Our Reference: 64076/PSN1

Re: P/2019/34799 - Highways England Post Submission Note 1

This letter has been prepared to address the various comments raised by Highway England's (HE) in their response to Planning Application Reference P/2019/34799, dated 13th June 2019, but received 17th July 2019.

Project: WARRINGTON SIX 56

Appendix A – Grappenhall Lane/A50 and M6 Junction 20 Mitigation Scheme

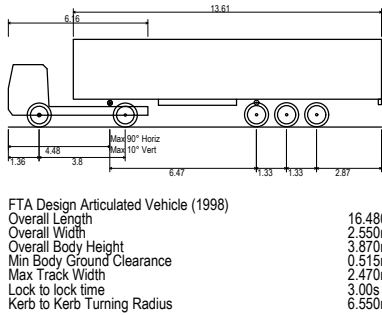
HE Comment	Curtins Response
There is a single lane exit on the A50 northbound and therefore two circulatory lanes at this point is unnecessary.	The Linsig has been amended to reflect a single exit lane.

Lane markings at the M6 J20 require a review;	Some of the lane markings have been reviewed and updated to better match the model. A slightly amended drawing is included at the rear of this response in Appendix A.
The signalised approach to the western dumb-bell roundabout could cause queuing on the circulatory carriageway; and	The modelling in the TA and the revised modelling considered later in this note does not show this as an issue.
The link capacity of the carriageway between the M6 Junction 20 and the Grappenhall Lane/A50 roundabout.	The mitigation package for the M6 J20 and Grappenhall Lane/A50 roundabout was developed to address this concern, which is why the link has been extended and traffic signals introduced to better control the flow of traffic onto the link. The mitigation proposed is a betterment of the Stobart scheme in this regard, and that application was recently approved.

P04	Road markings updated	29/07/19	DD	AV
P03	Footways updated	08/01/19	DD	AV
P02	Cliff Lane Roundabout: Northern arm entry updated	28/11/18	DD	AV
Rev:	Description:	Date:	By:	Chkd:

Orig Title: M6 J20 - WESTERN ROUNDABOUT
POTENTIAL IMPROVEMENTS
SWEPT PATH ANALYSIS
16.5m ARTICULATED HGV

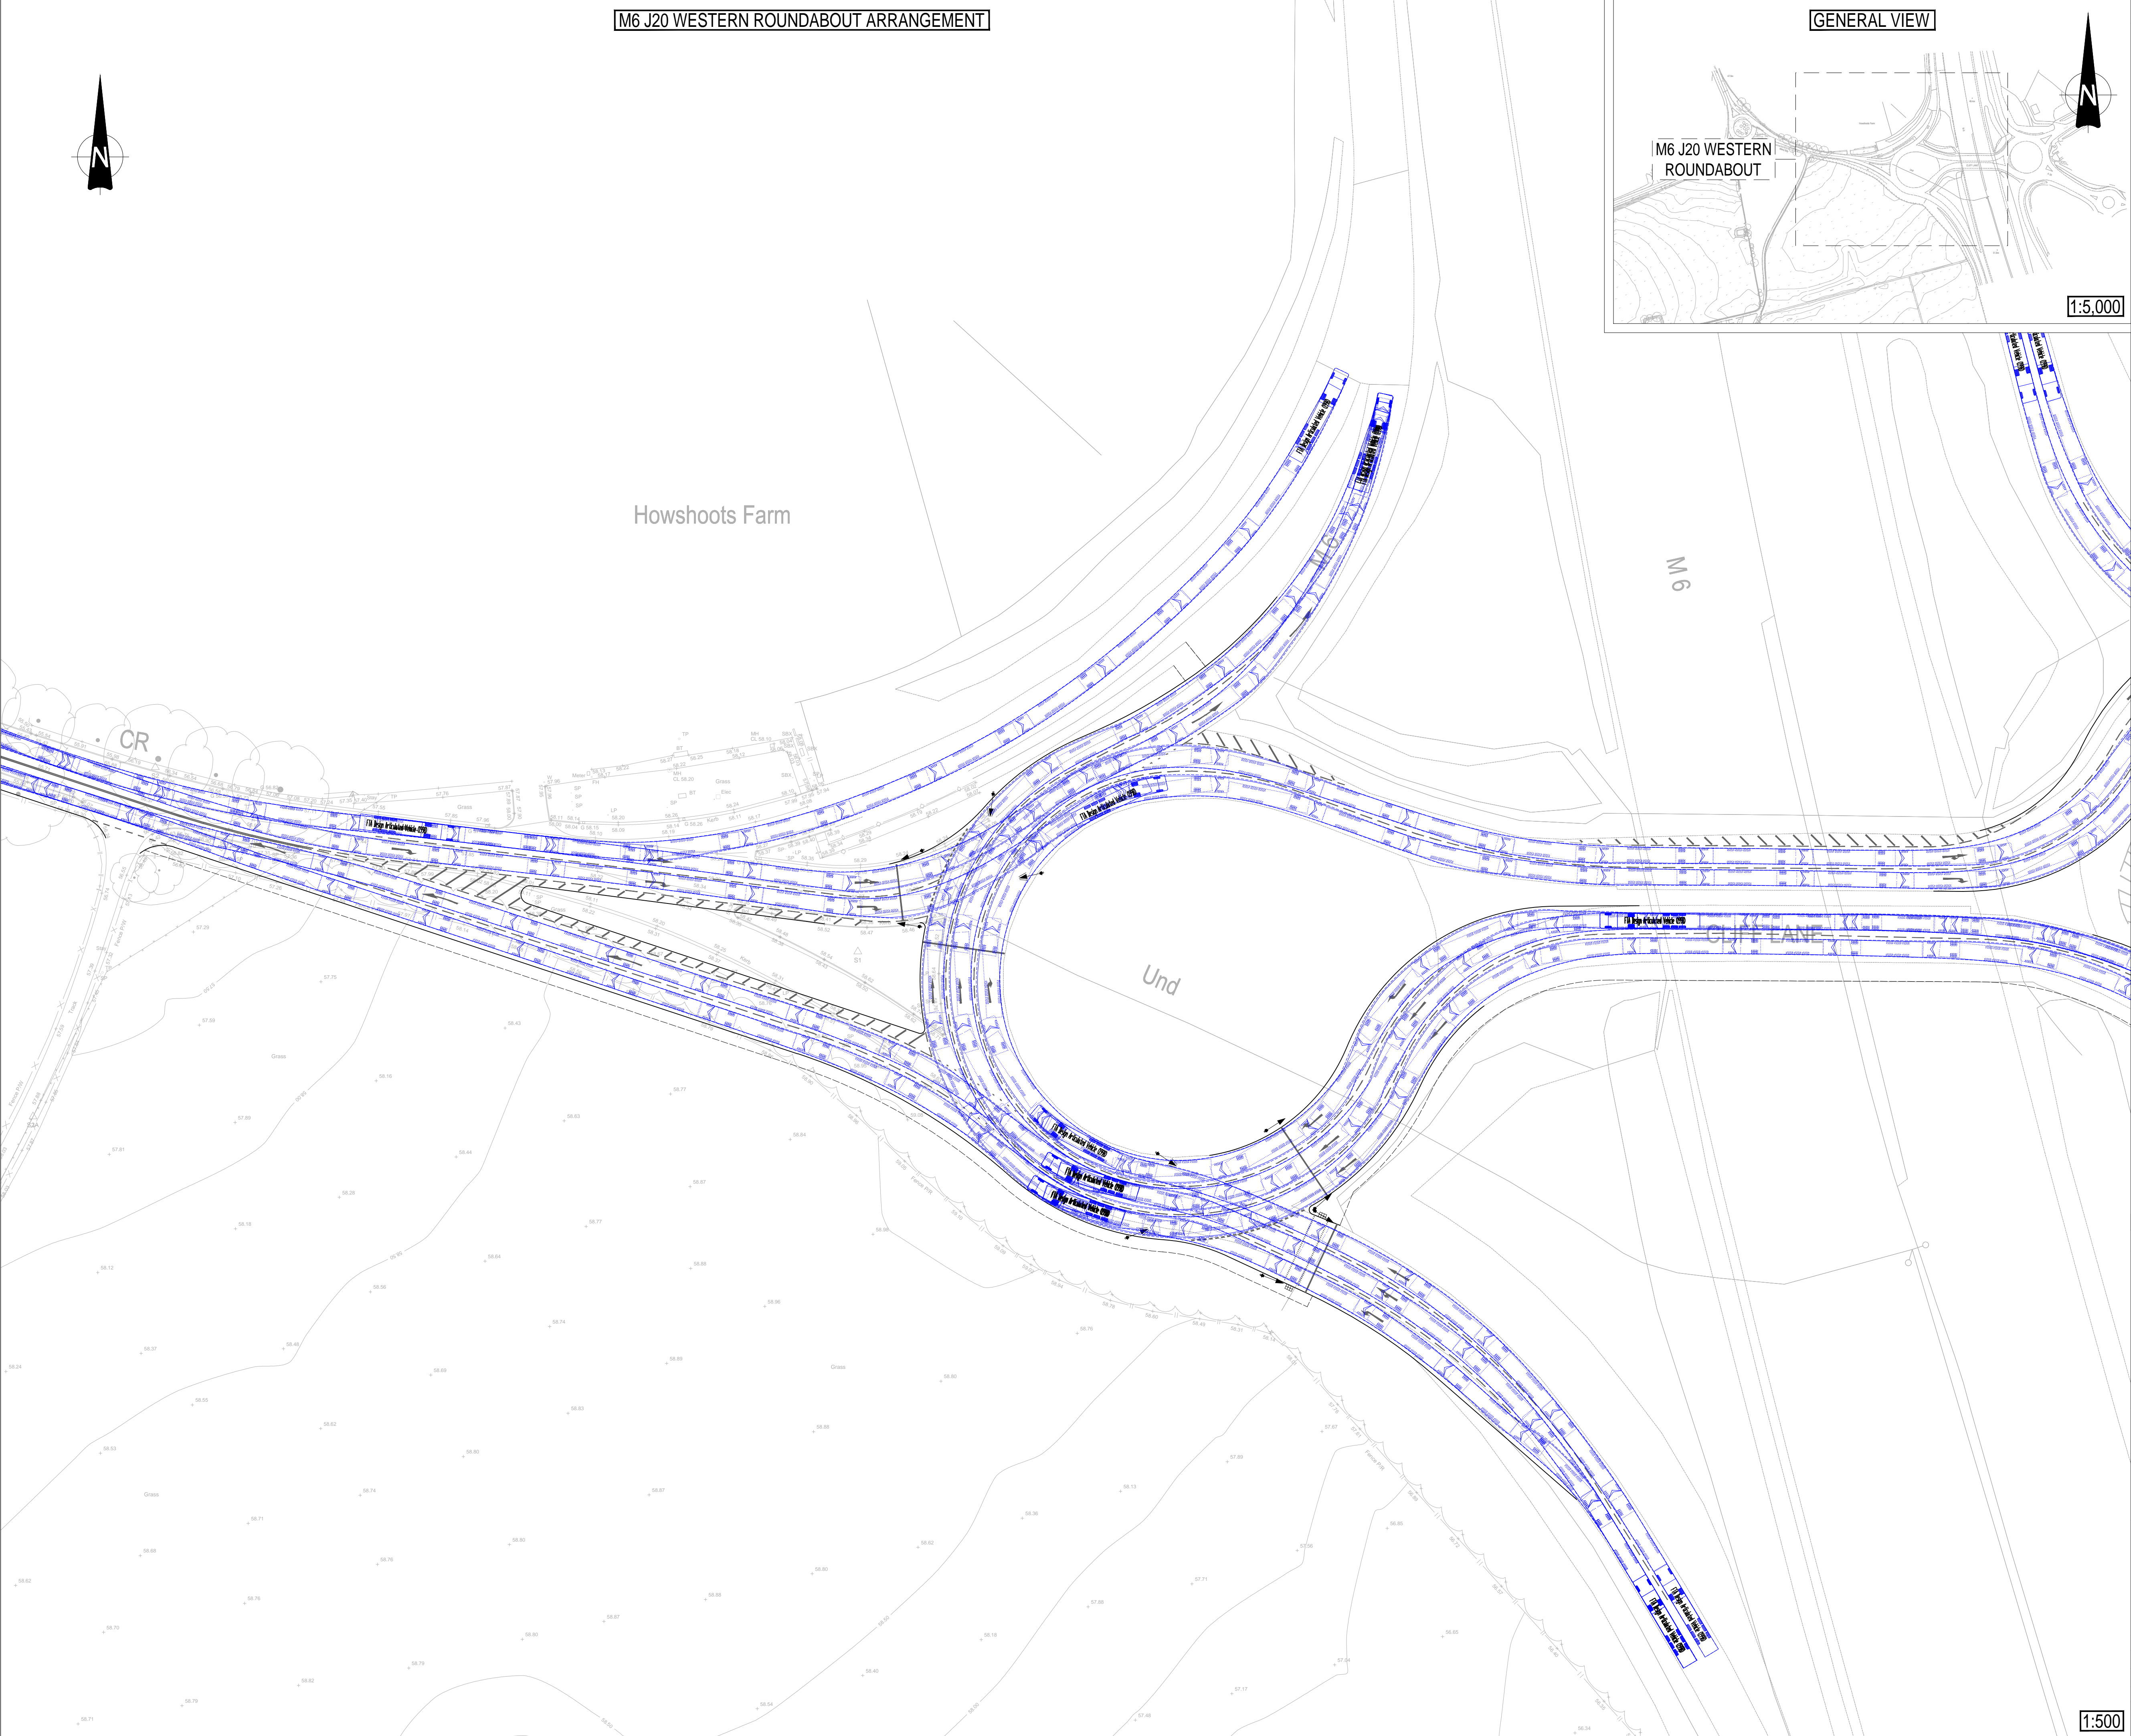
- Arm J2:4 – The LinSig model has been amended.
- Arm 2:1 – Drawing has been updated.
- Arm J2.2 - Drawing has been updated.
- Arm J1:7 - The LinSig model has been amended.

P02	Layout updated	12/09/19	DD	FF
Rev:	Description:	Date:	By:	Chkd:

Orig Title: M6 J20 - EASTERN ROUNDABOUT
POTENTIAL IMPROVEMENTS
SWEEP PATH ANALYSIS
16.5m ARTICULATED HGV

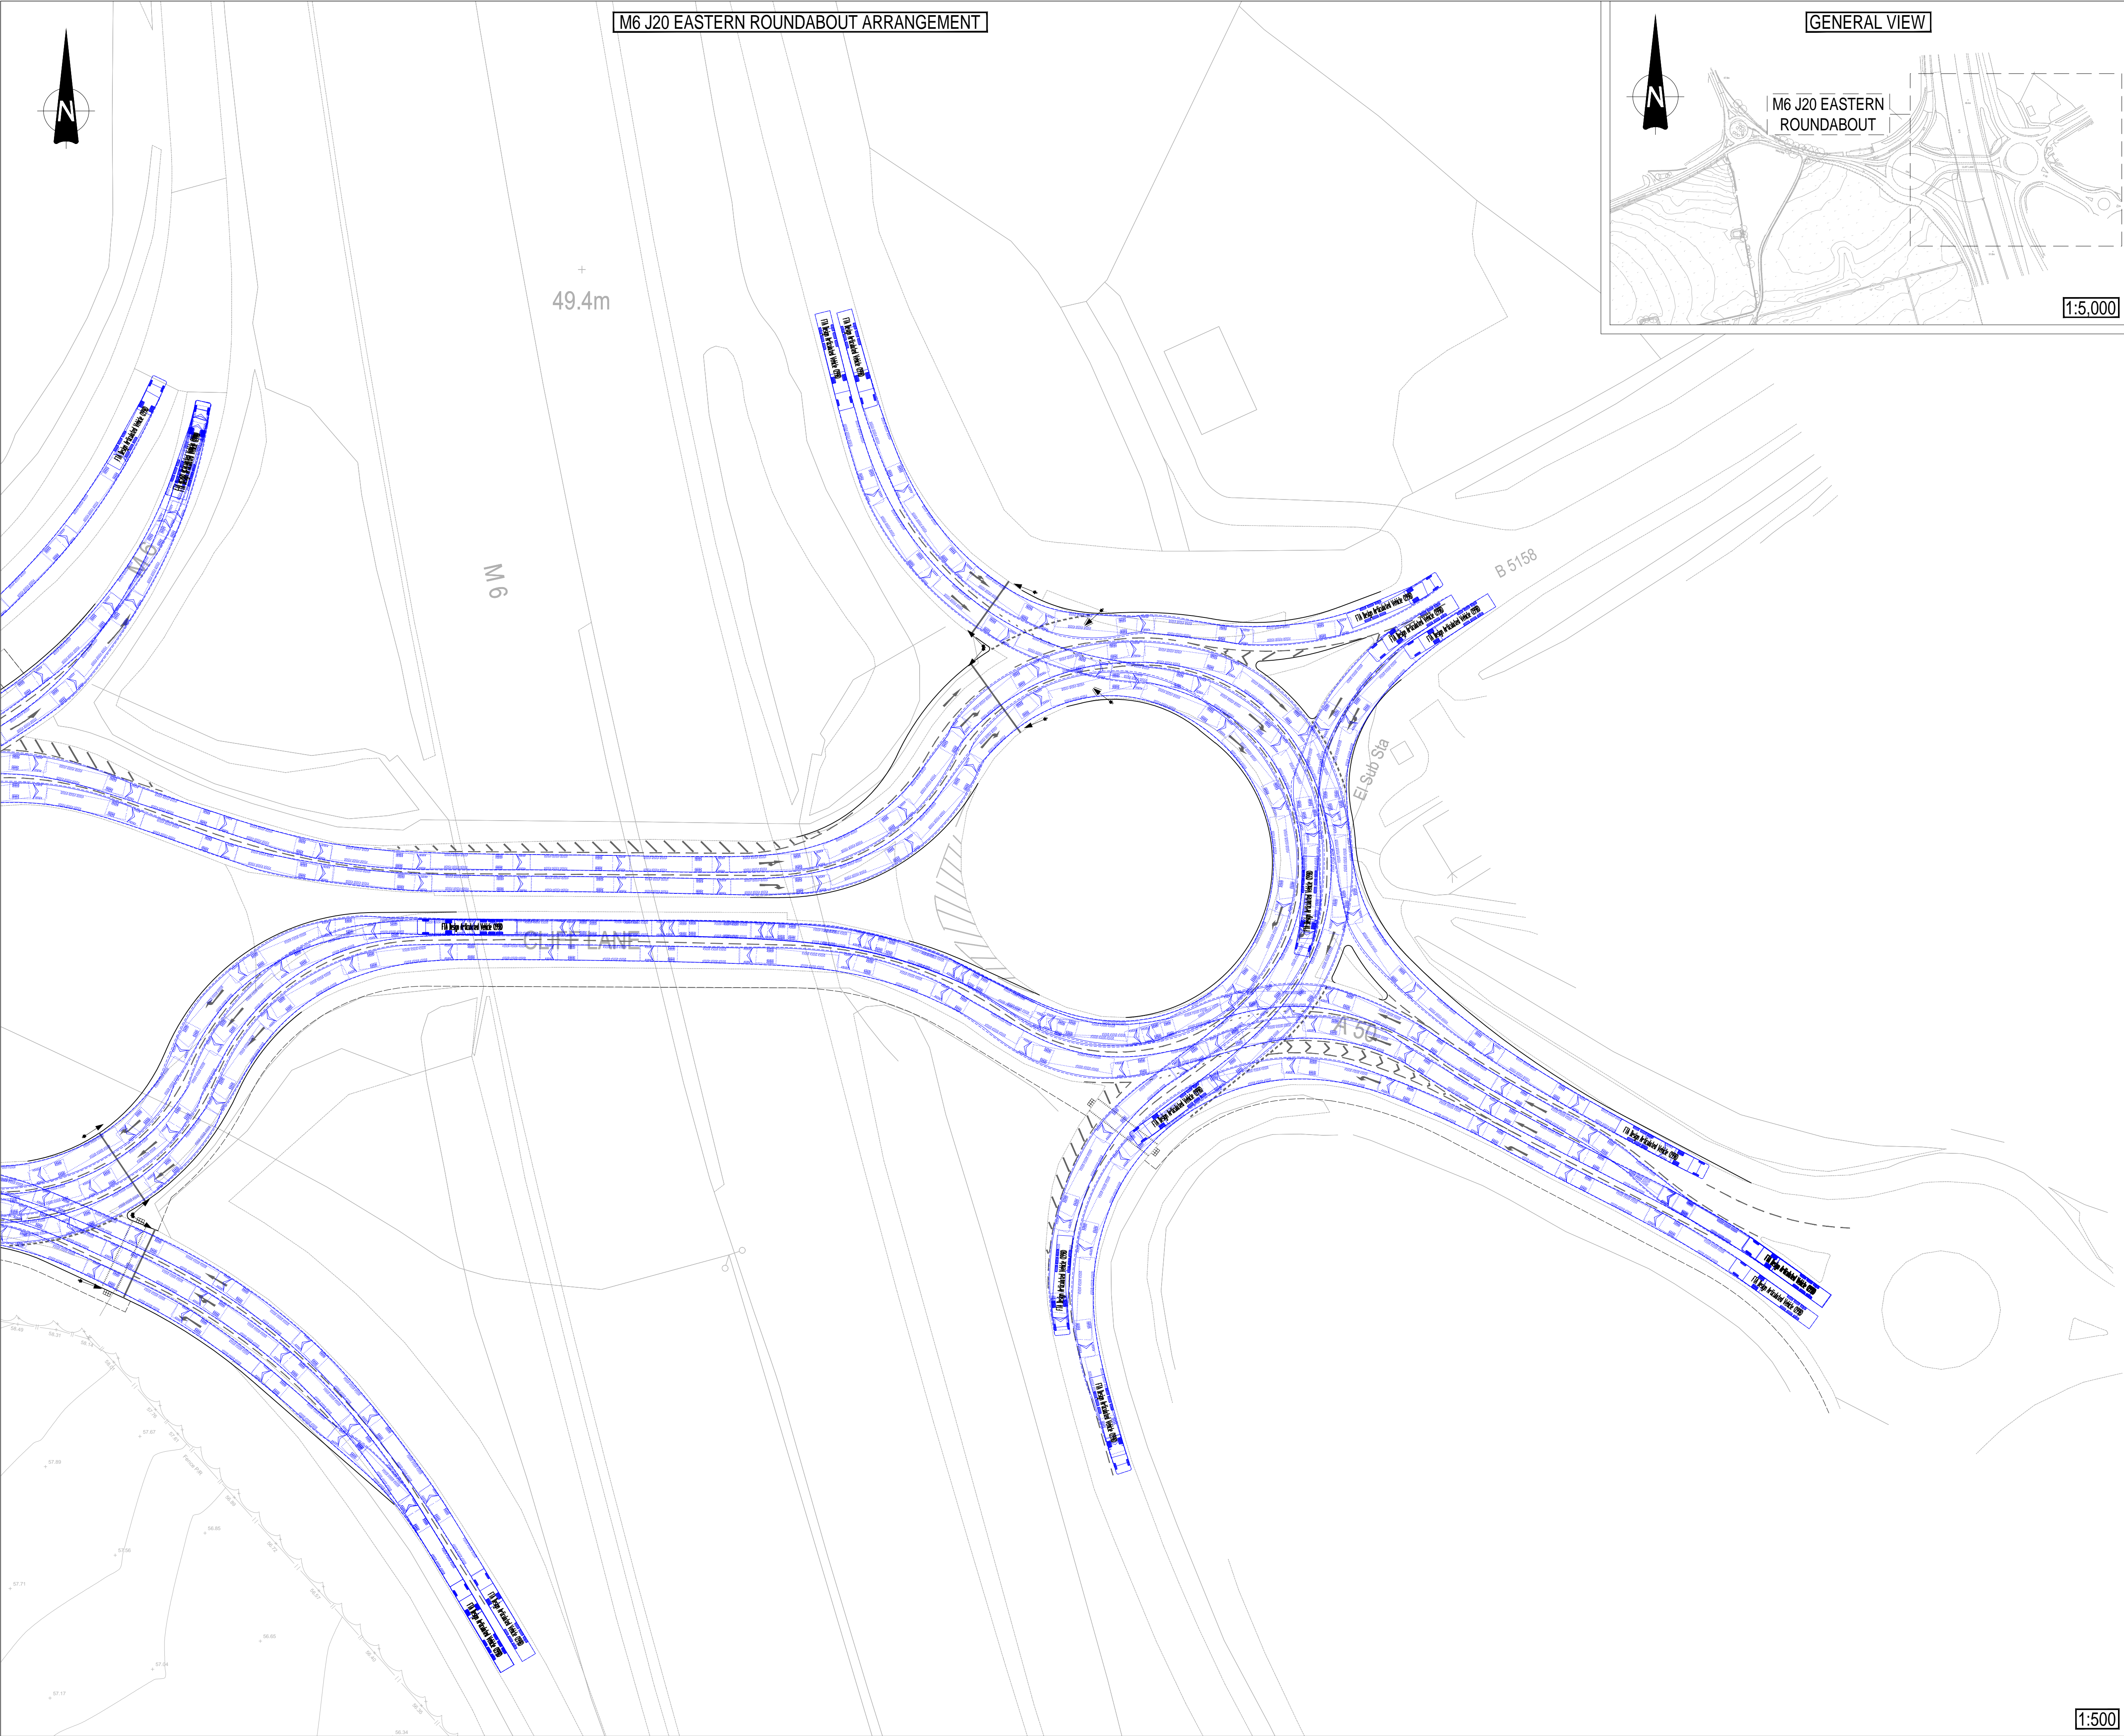
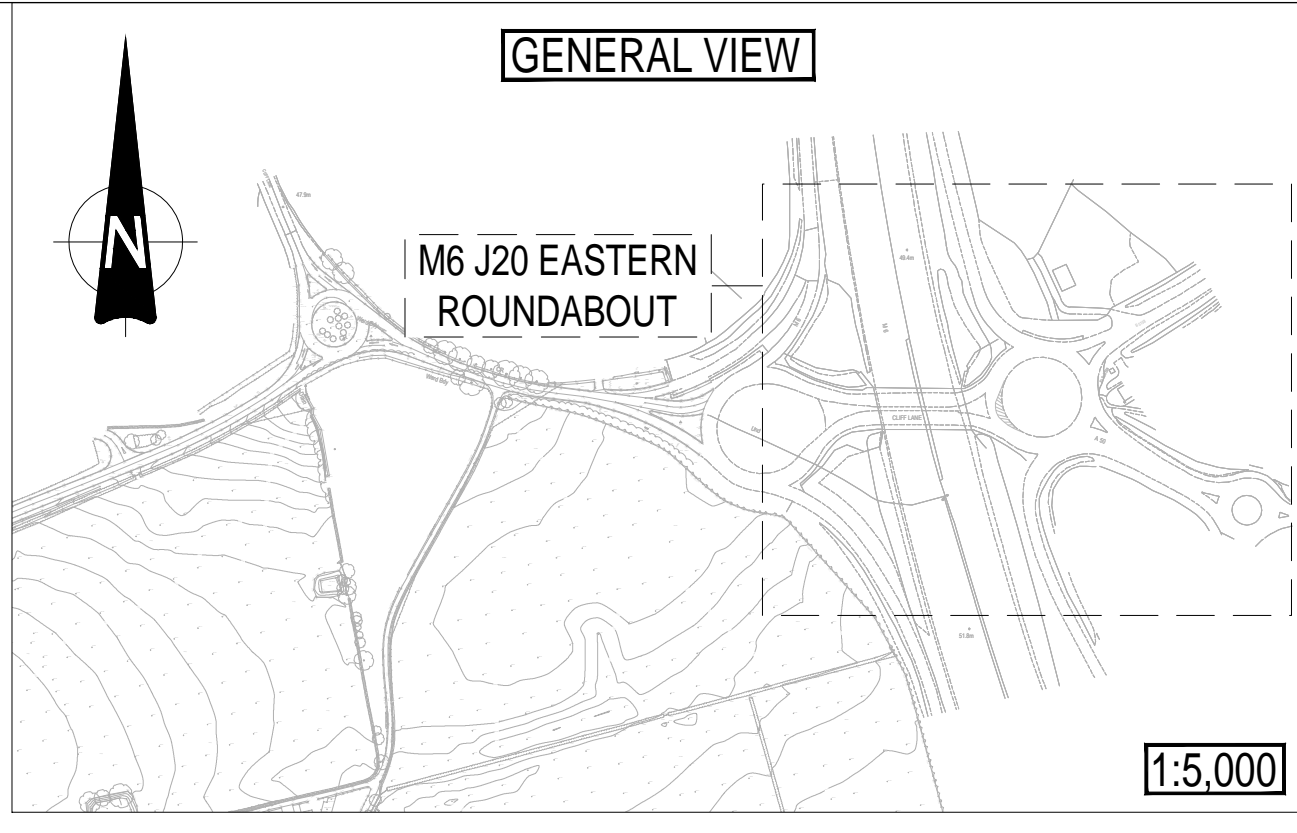
The response also acknowledges that closing off the circulatory carriageway on the western side of the eastern roundabout would be beneficial.

P02	Layout updated	12/09/19	DD	FF
Rev:	Description:	Date:	By:	Chkd:
